BORDERS BOAT DOCK 1 BOAT DOCK CONSTRUCTION

SP-2021-0084D

Hydrogeologic Reviewer

Watershed Protection Department

VARIANCE REQUEST

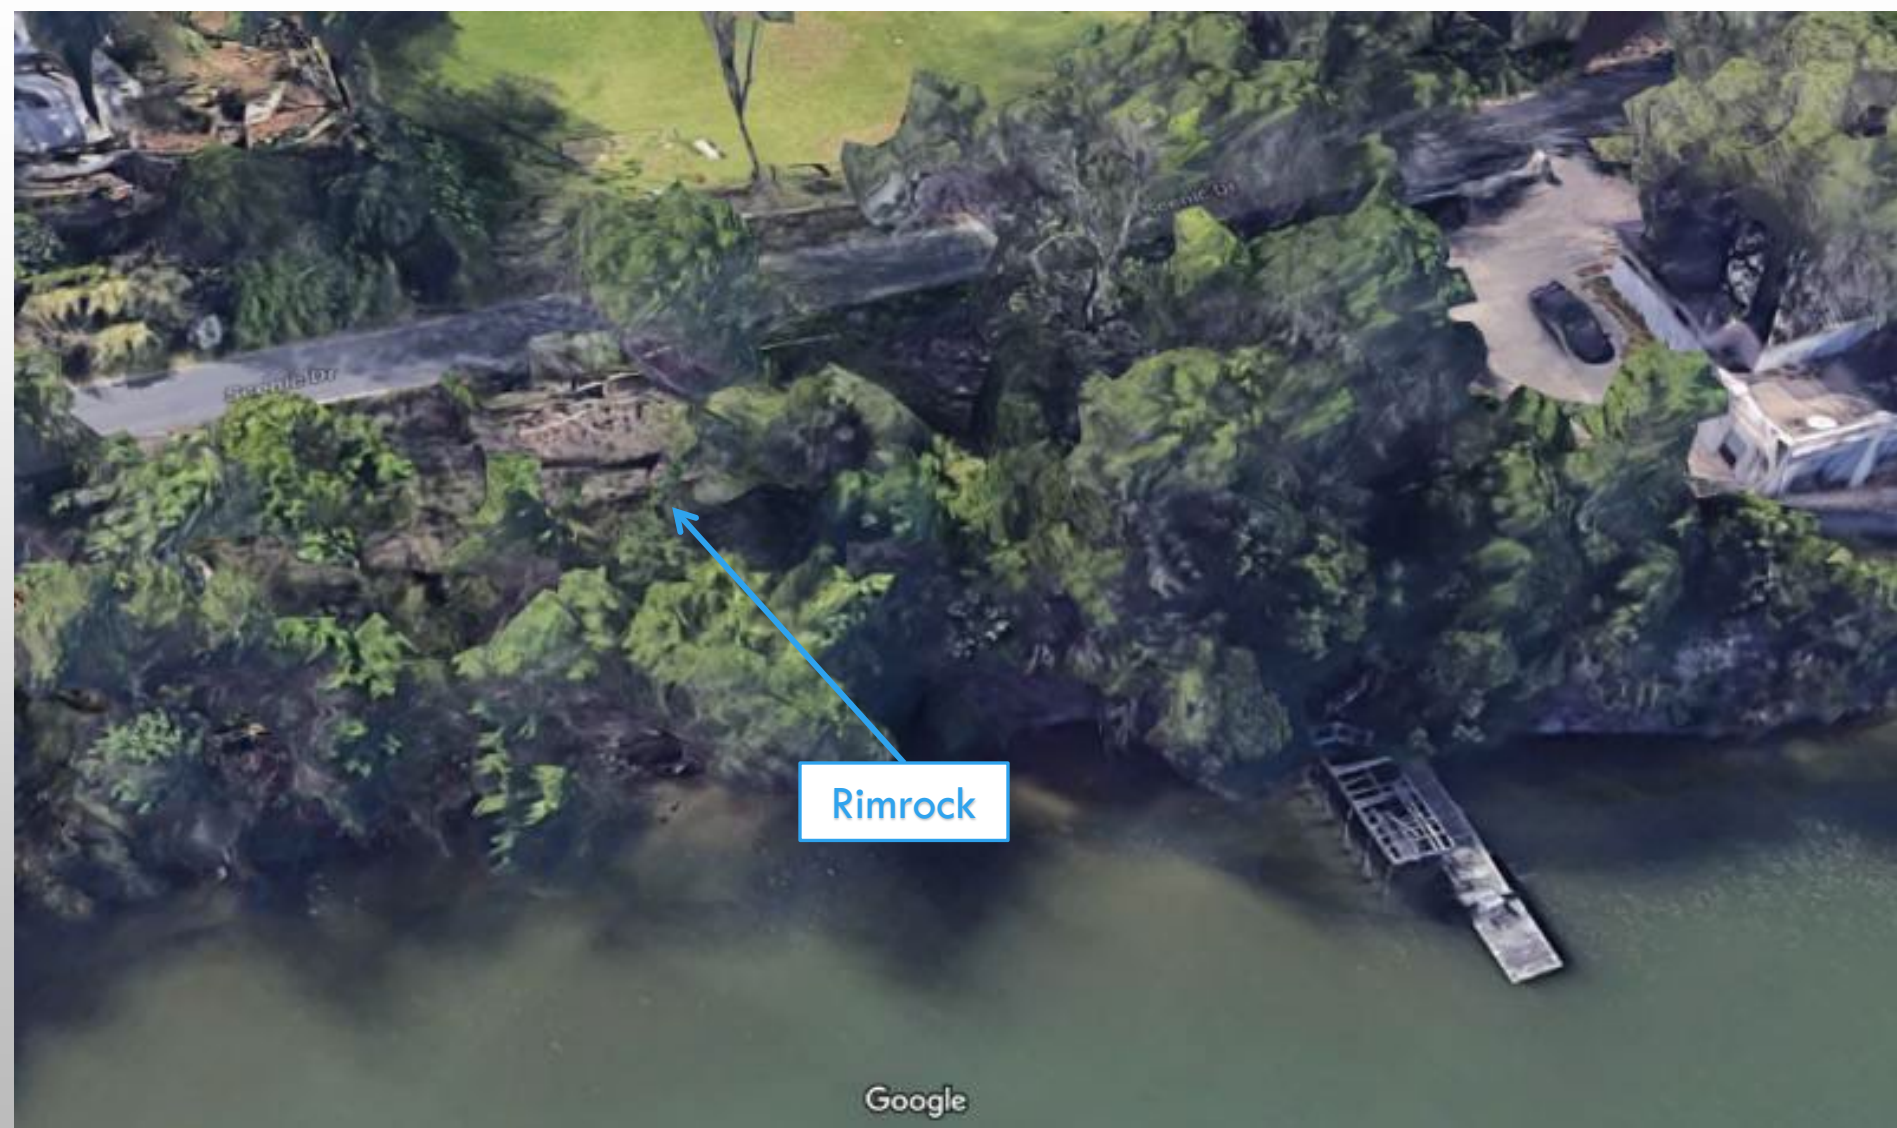
REQUEST TO VARY FROM LDC 25-8-
281(C)(2)(B) TO ALLOW CONSTRUCTION
WITHIN 150-FOOT OF CRITICAL
ENVIRONMENTAL FEATURE (CEF) BUFFERS.

FINDING OF FACTS HAVE BEEN MET.

STAFF RECOMMENDS THE APPROVAL OF THIS VARIANCE WITH THE CONDITION THAT ALL CONSTRUCTION BE COMPLETED BY BARGE AND PROFESSIONAL ENGINEER CERTIFY NO LONG-TERM IMPACTS TO RIMROCK FROM CONSTRUCTED ACCESS TO DOCK.
